TO: Tony Gomillion, County Administrator
FROM: Stephen Furman, Public Works Director 
DATE: Oct. 28, 2016
SUBJECT: Holley-Navarre Water System Request to Open Cut Panhandle Trail

RE: Panhandle Trail (LS #18) Master Lift Station Relocation

PANHANDLE TRAIL (LS#)
LIFT STATION RELOCATI
HOLLEY-NAVARRE WATER SYSTEM, IN
SANTA ROSA COUNTY

EXISTING LIFT-STATION CONNECTION DETAIL

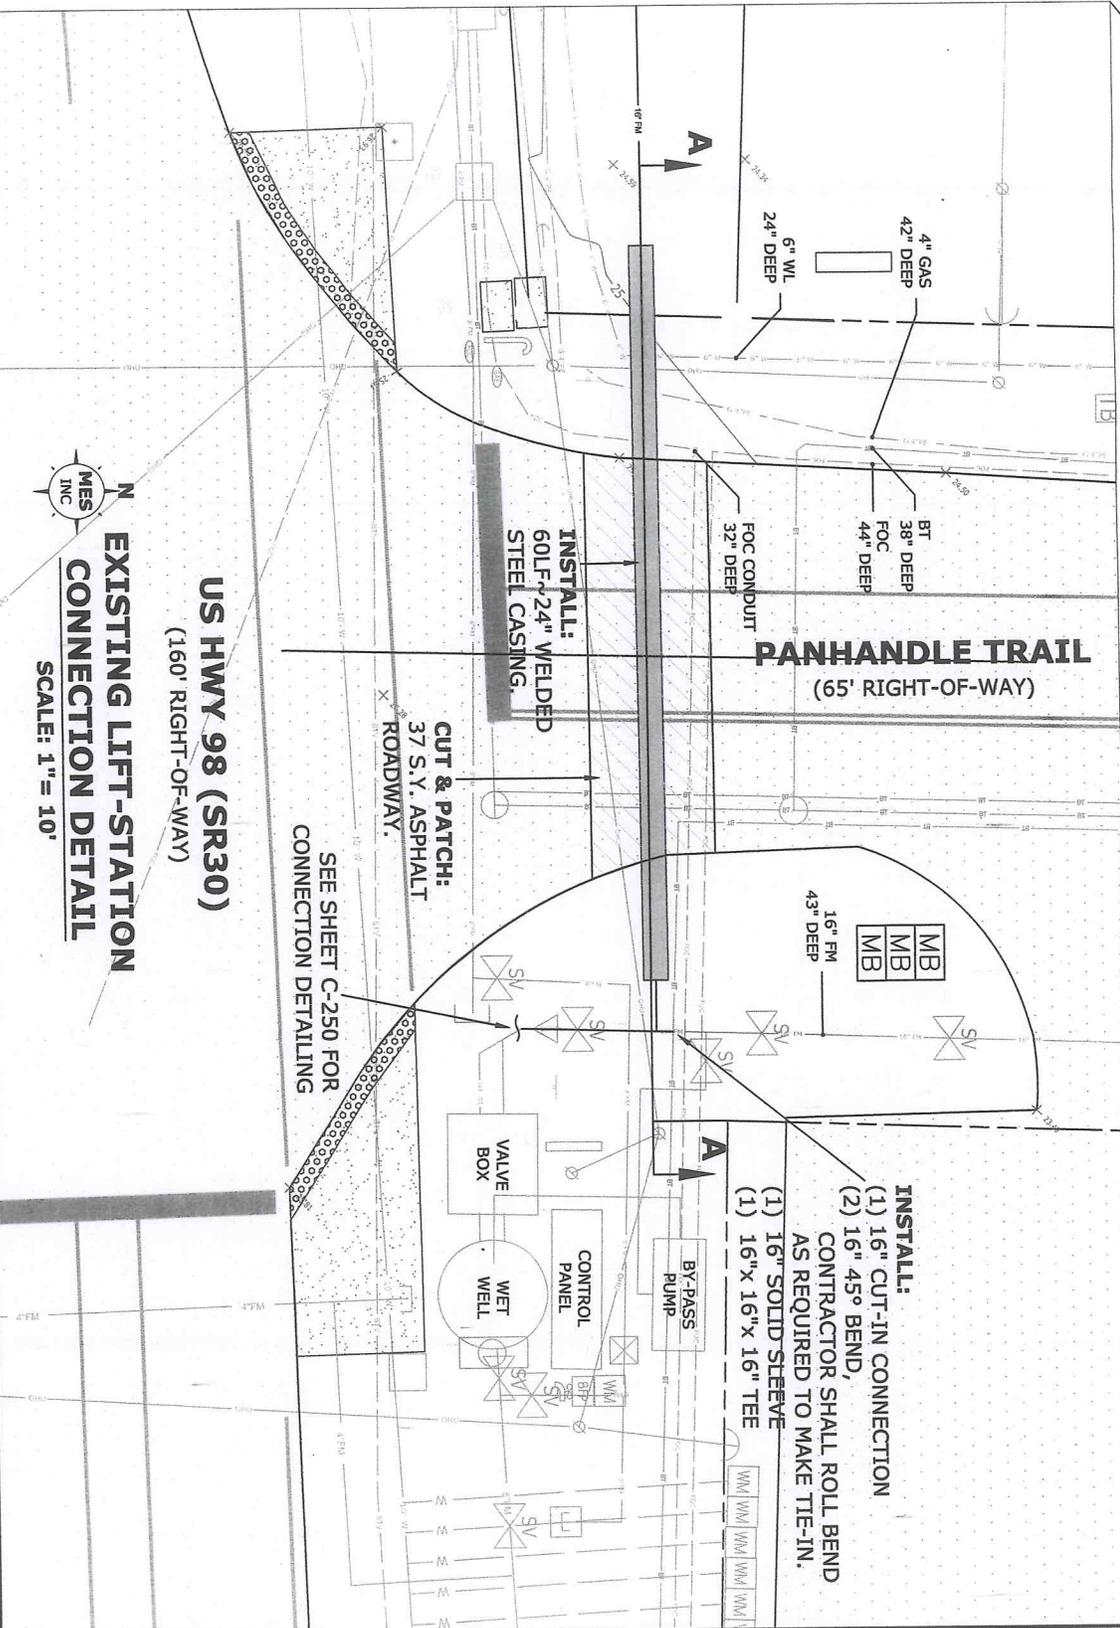
Discussion of request from the Holley-Navarre Water System to open cut Panhandle Trail for the installation of a 16 inch sewage forcemain.

We have received a request from Dale Long, P.E., of Municipal Engineering Services, Inc., on behalf of the Holley-Navarre Water System, for the water system to be allowed to open cut Panhandle Trail for the purpose of installing a 16 inch diameter sewage forcemain. The request includes the provision that they will require their contractor to perform the work during nighttime hours, and that one lane will remain open for travel. The request for the open cut, versus a boring, is based on the number and close proximity of other underground utilities. Several exploratory holes would be required to be cut through the pavement for utility depth and location verification, thus creating a patched surface, even if the line is installed with a boring technique.

Pursuant to our conversation this morning and meeting on site, we would like to formally request authorization to open cut Panhandle Trail just north of Highway 98 in Navarre. We have considered both directional drilling as well as jacking and boring this crossing as an alternative to open cutting. Unfortunately, due to the limited right-of-way available, the location of the connection to the existing line, and the myriad of existing utilities there is no way to successfully bore the road.

To this end, we ask for the County's approval to open cut the road. As you can see from the attached plan, we intend to encase the PVC in a welded steel casing to protect the road and the carrier pipe. We will require the contractor to make this crossing during nighttime hours to reduce the impact on the traveling public and will maintain one lane of the road open at all times.
